Application Number **P24-26**

P24-26
West Smith Road New Home

Property Owners: James and Elizabeth Vanderpool
Applicant: John Potter
Location: 322 West Smith Road
Zoning: C-2 (Central Business)
Request: Certificate of Appropriateness approval for a two-family home in the TC-OV District

ELEVATIONS
AND DETAILS

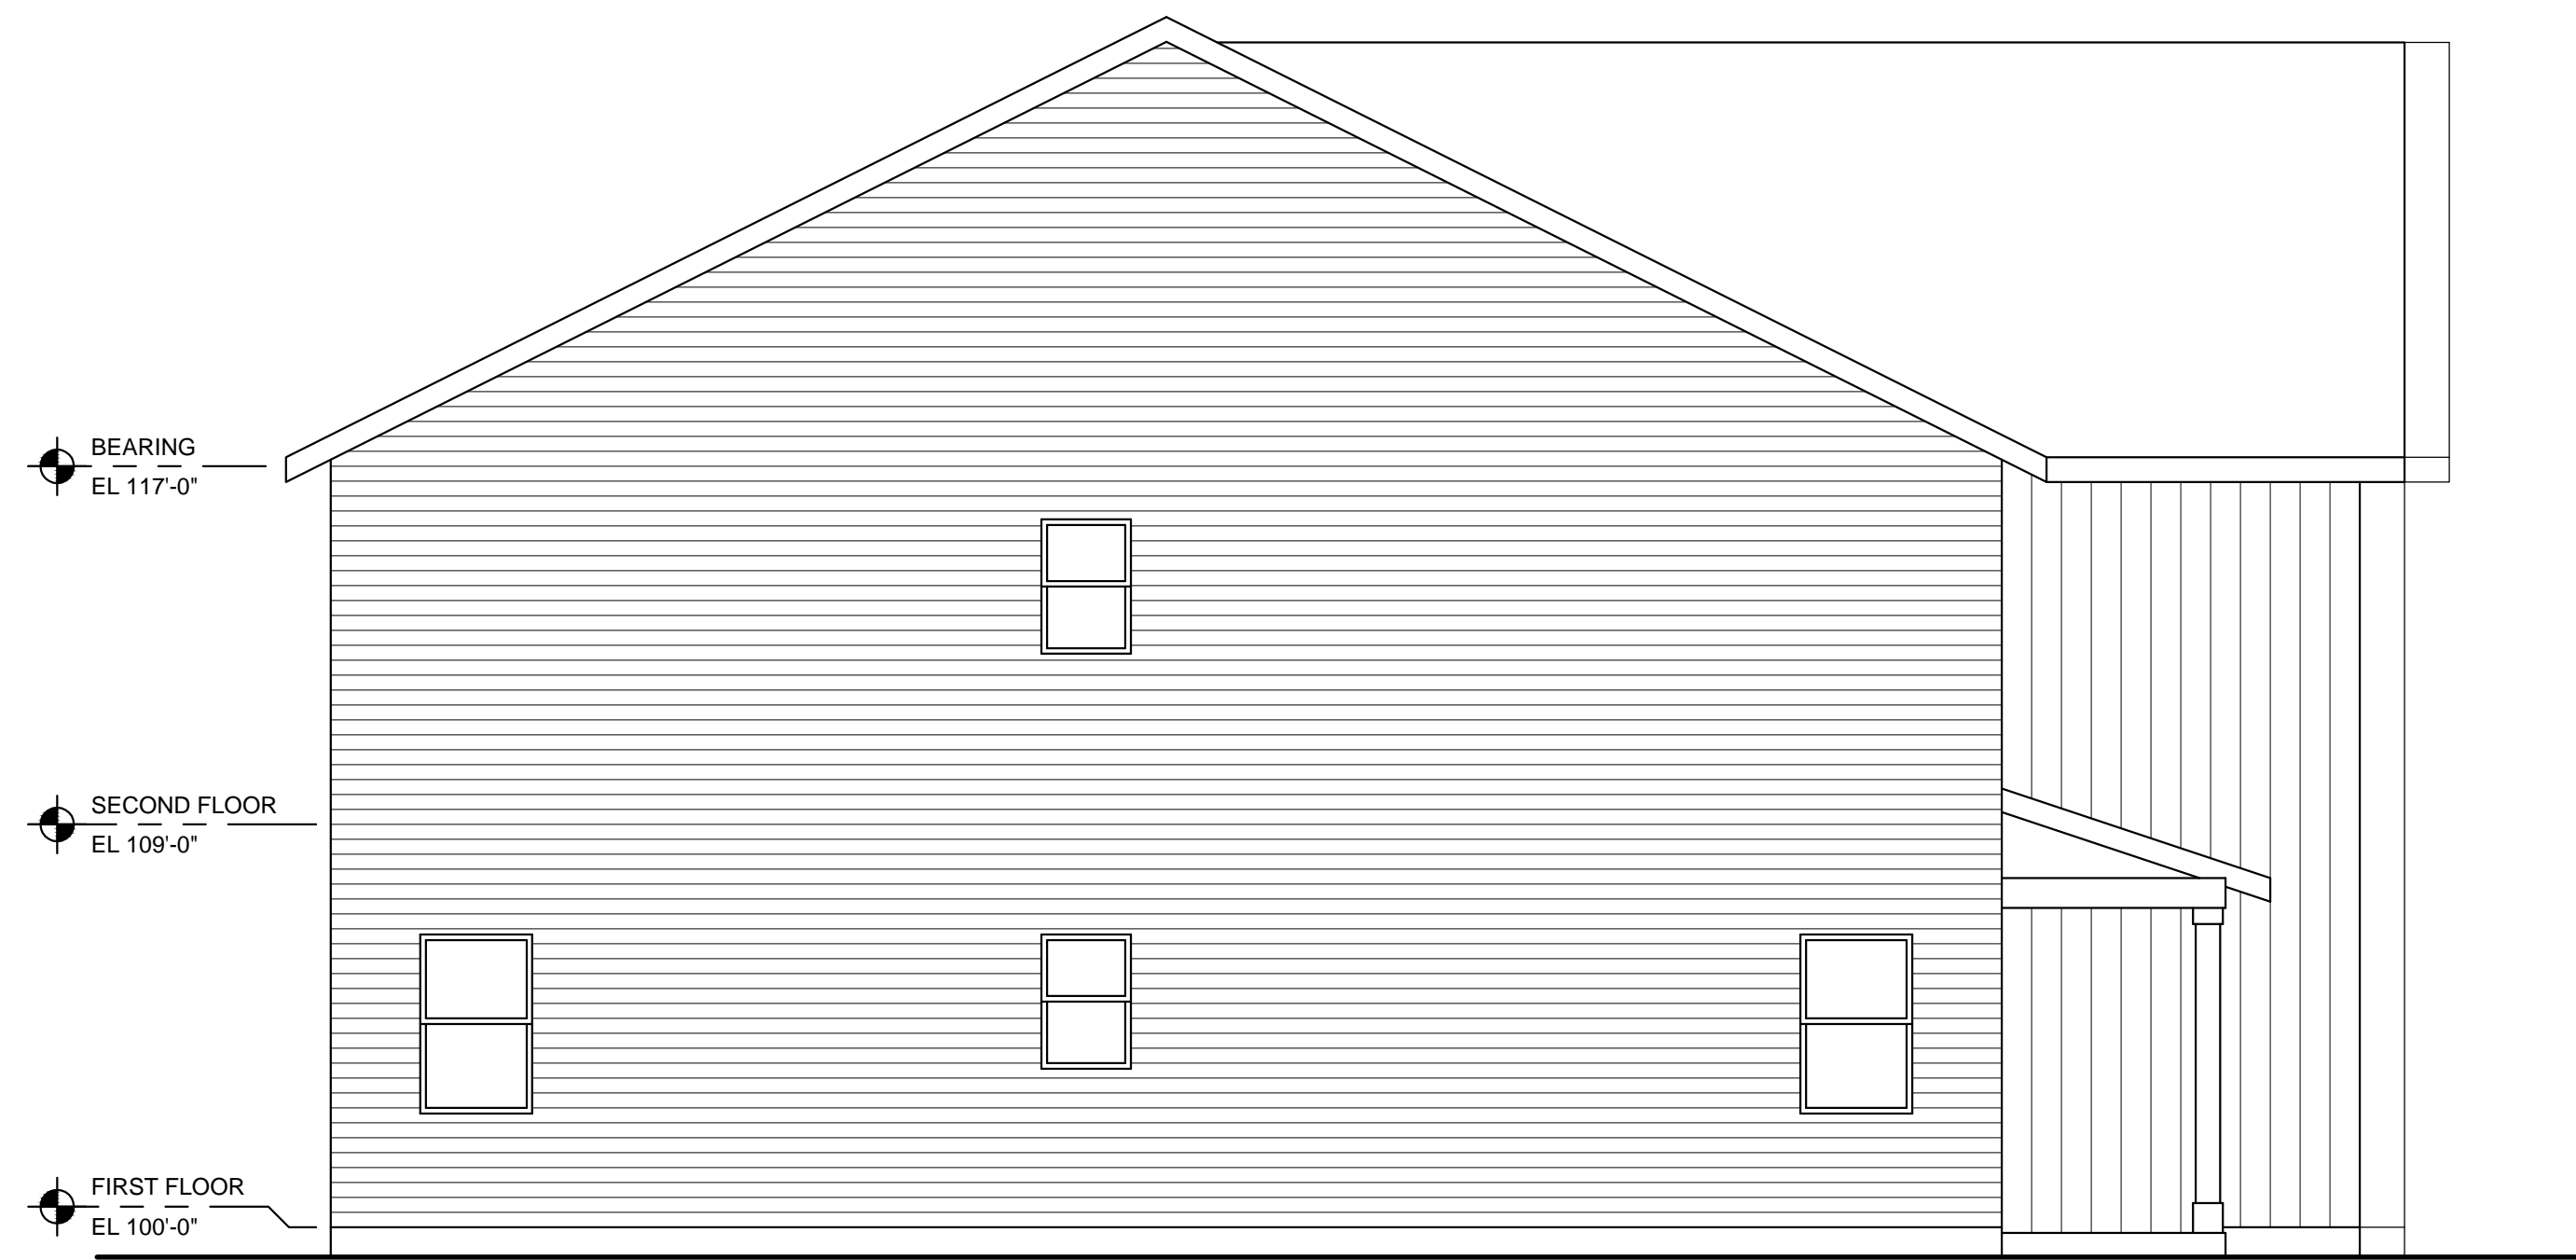
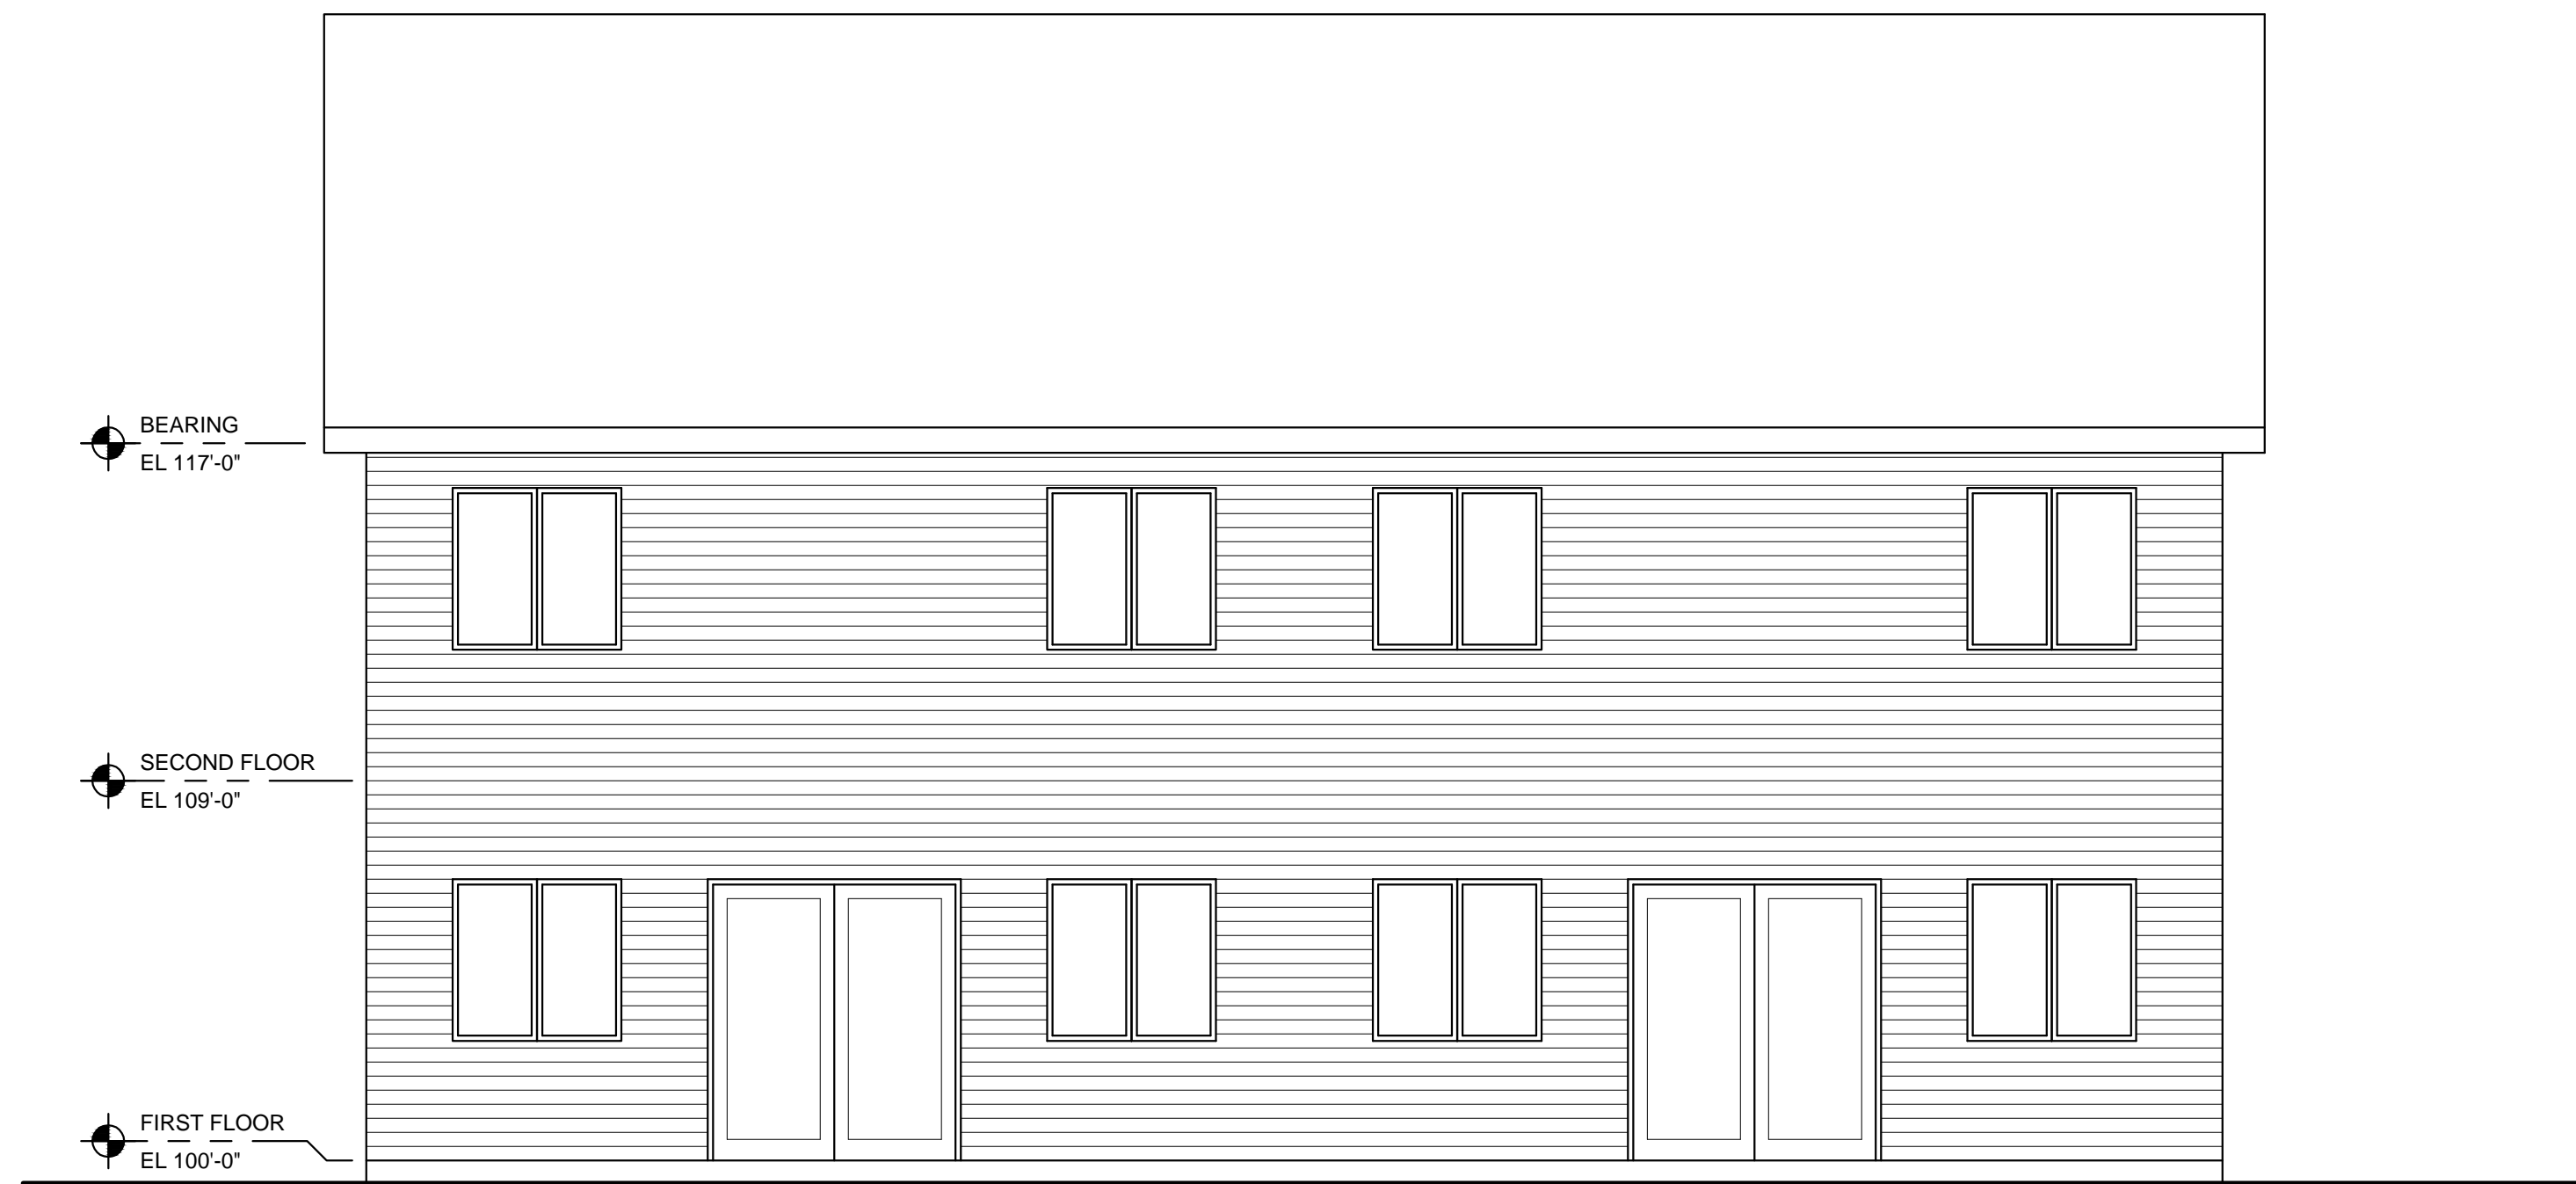
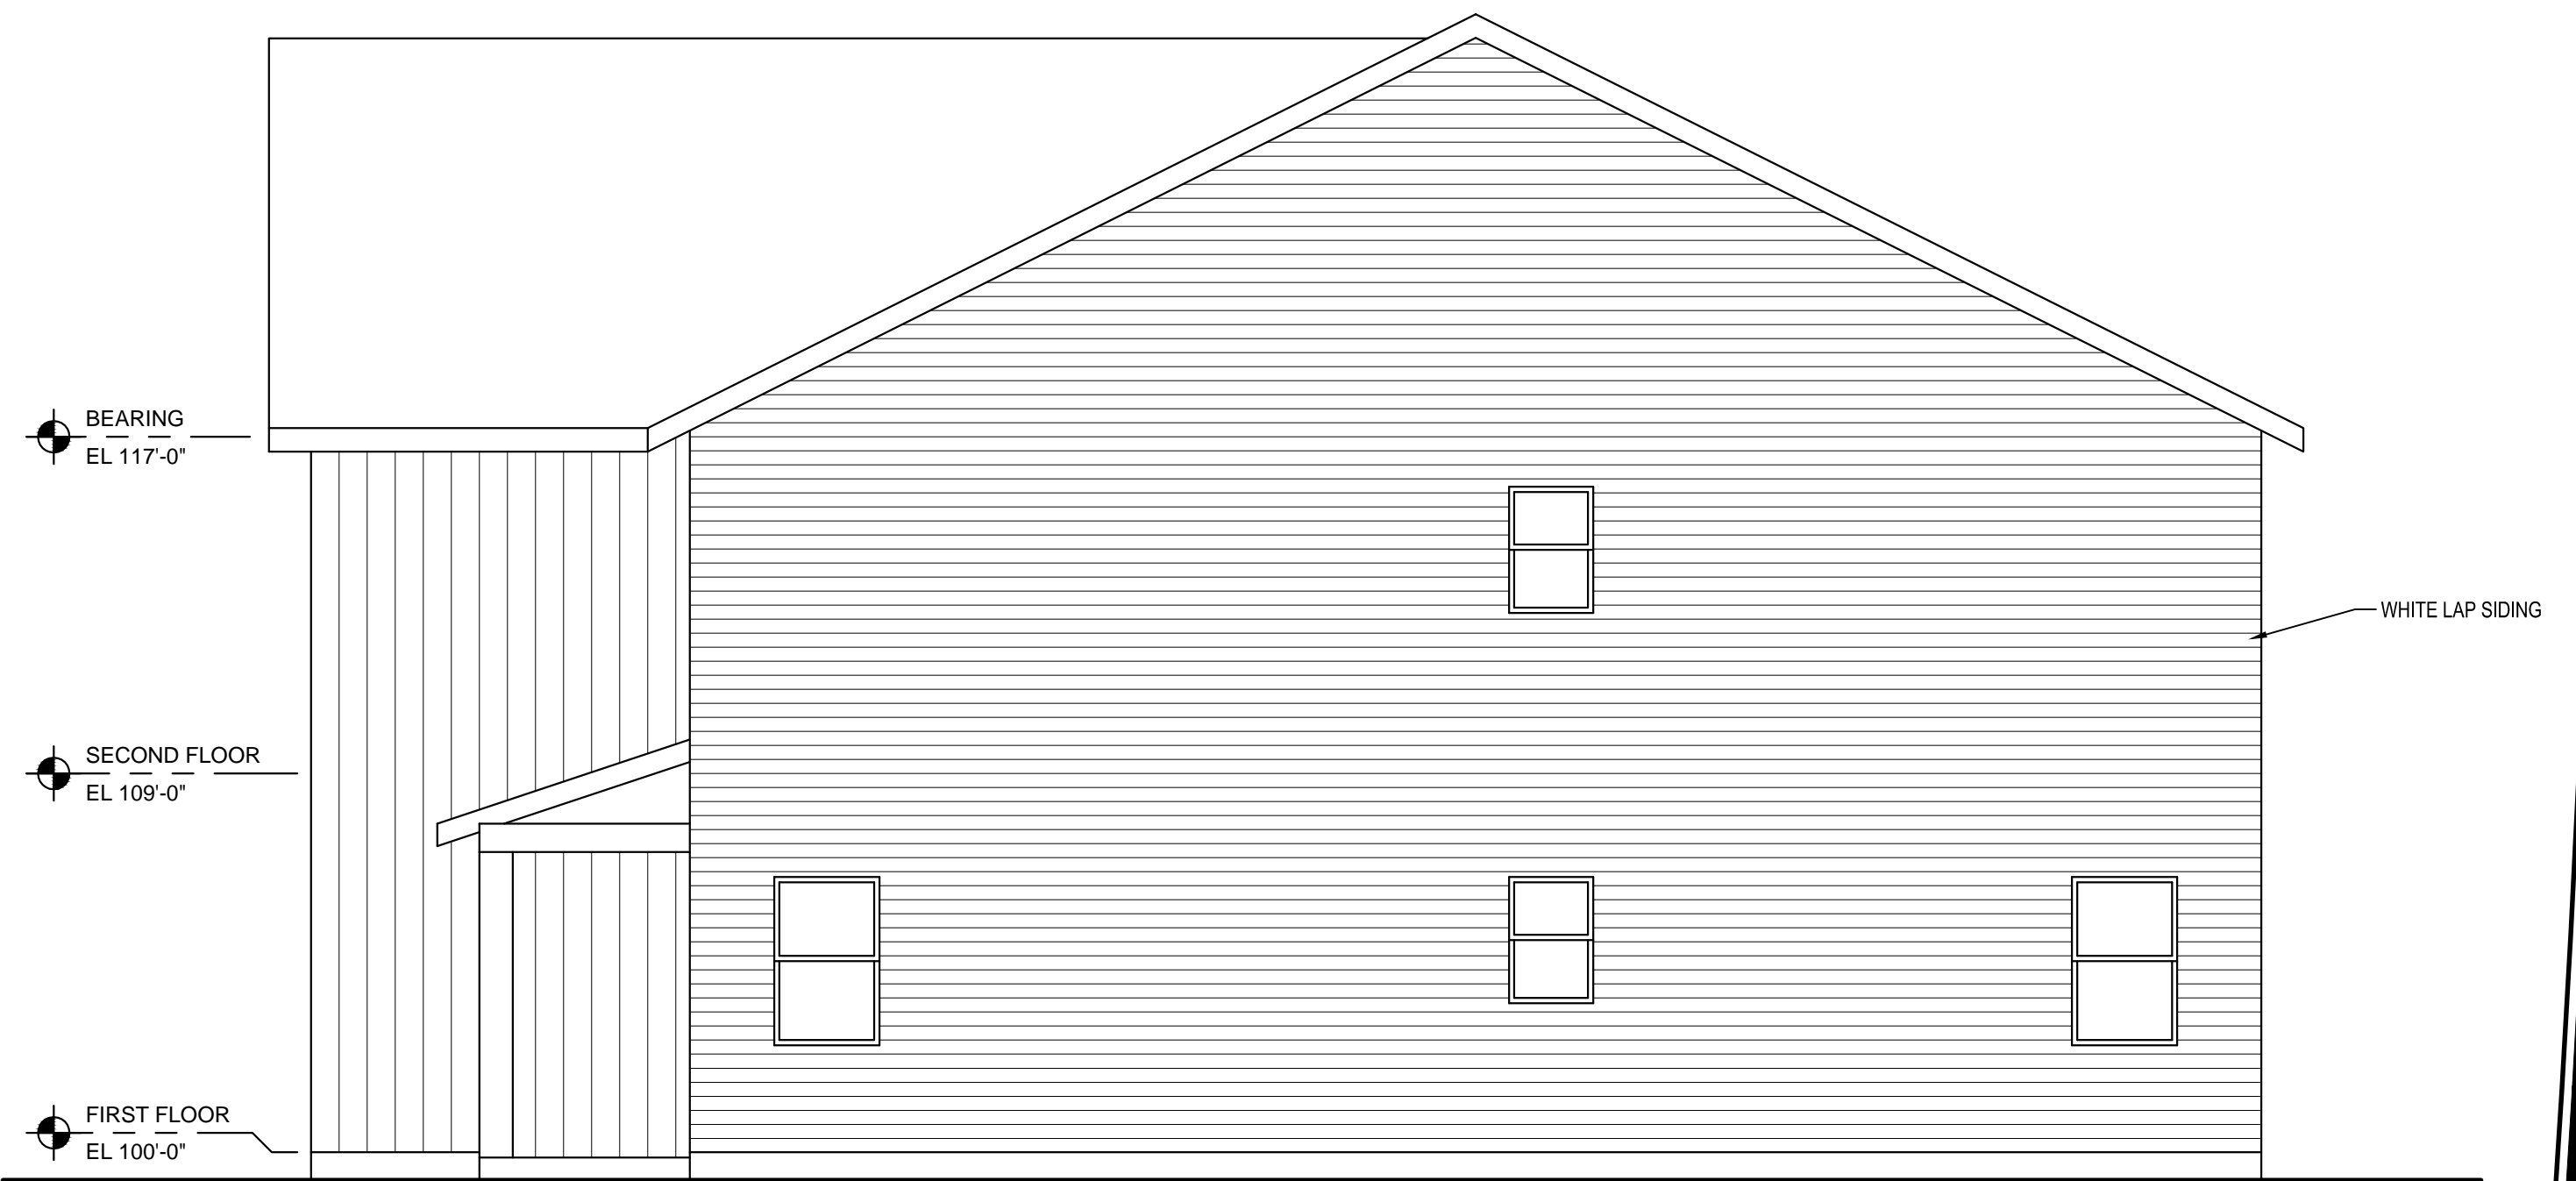
Section 1135.13 includes several architectural standards that apply to buildings in the C-2 zoning district. As the standards are tailored to commercial development, Section 1135.13(c)(1) limits the use of vinyl siding to 15% for building elevations facing the right-of-way. The proposed building elevation facing the West Smith Road right-of-way is clad in 8 in. vinyl board and batten siding. The applicant has filed a variance to Section 1135.13(c)(1).

Staff recommends approval of application P24-26 as submitted with the condition that the project shall receive variance approval from the Board of Zoning Appeals to Section 1135.03 regarding use, Section 1135.06 regarding the rear yard setback, Section 1135.08(a) to allow parking in the front yard, and Section 1135.13(c)(1) regarding the use of vinyl facing the right-of-way.
